Ms Kathryn Saunders
Senior Development Assessment Officer
Penrith City Council
PO Box 60
Penrith NSW 2751
C/- kathryn.saunders@penrith.city

DA18/0264 | RESPONSE TO PRELIMINARY ASSESSMENT

Figure 1 – Development Staging Plan

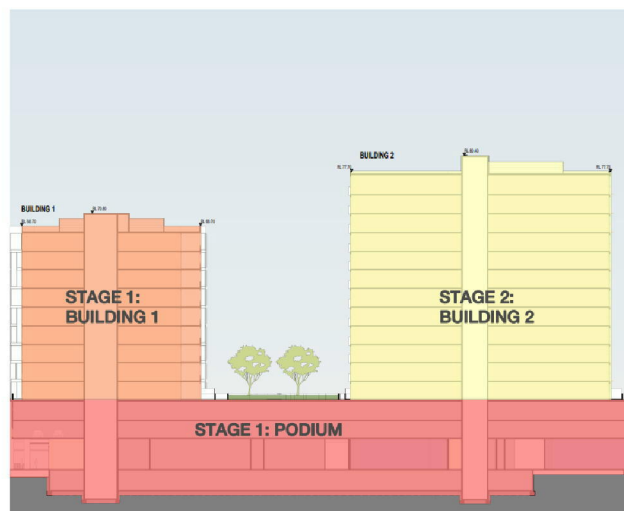
- Confirm the intention that the proposed development will be constructed in stages, with a requirement for an Occupation Certificate to be issued for the podium, public domain works, and Building 1, prior to the completion of Building 2. The proposed 'staging' for the development is illustrated in the plans included at **Attachment 1**, and as extracted at **Figure 1** below.

Figure 3 – Diagram illustrating transition in built form and land use intensity on site and surrounds

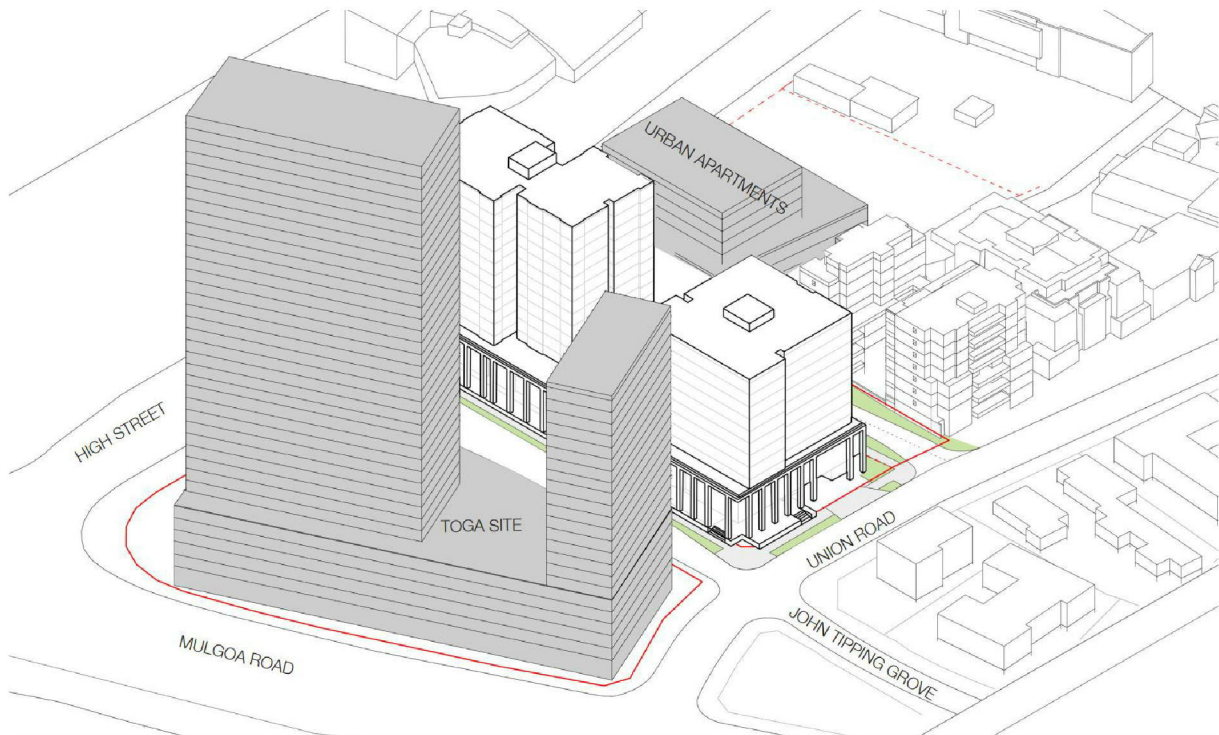
It is not demonstrated that the proposed heights will provide a high quality urban form and an acceptable transition in built form and land use intensity.

- The image provided at **Figure 3** illustrates the transition in built form and land use intensity proposed on the site compared to existing development and future development to the west.

The proposed heights of the development will provide a transition in built form between the existing development and the future development to the west of the site. This is demonstrated conceptually within **Figure 2** of this letter, and within the photomontages provided with the DA.

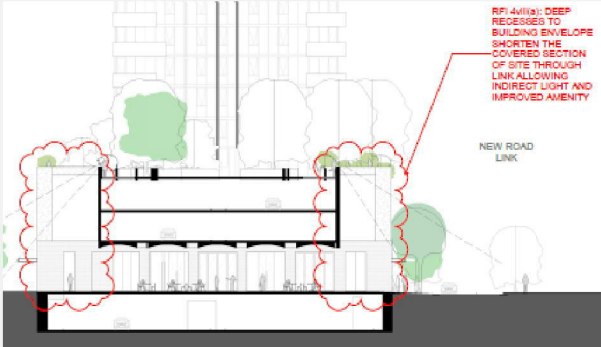
Ground Floor and Public Domain	
<p>(a) The ground floor east/west link is fully enclosed by glazing at each end and due to its length and narrow proportions will not allow adequate solar penetration to contribute amenity of the link for future retail tenancies. The southern elevation of the link is dominated by blank walls and service doors. The connection of the link to the eastern side of the western colonnade is narrow and no clear way to the link will be visible.</p>	<p>Gates are proposed at the end of the east/west link for security for the development. Gates are to be open during commercial operating hours.</p> <p>The northern side of the link will be glazed and the southern wall has been articulated with brick patterns.</p>

Council Comment	Applicant Response
	<p>The design of the proposed through-site link was refined through the design development sessions with the Design Competition Jury prior to the lodgement of the DA. While one side of the link is not activated with commercial premises, the full northern link provides activation to this link, and further the design of the link has been refined to improve solar access to this space as illustrated in the following diagram prepared by SJB. Further, perspectives and reference images for the pedestrian link are provided at Attachment 17.</p> 
<p>(b) To assist in site penetration and access, the lobby area for Tower 2 should be open to John Tipping Grove.</p>	<p>The Tower 2 lobby has been specifically designed to be accessed from the new road as:</p> <ul style="list-style-type: none"> • This provides greater activation of the new road compared to the natural pedestrian attractors of High Street and John Tipping Grove and enhances 'way finding' for visitors to the tower entrance from the street. • Commercial frontages are provided to John Tipping Grove to activate this future public open space. • Providing access to the Tower 2 lobby from the new road provides greater incentives for residents to use the through-site link, activating this space and providing more
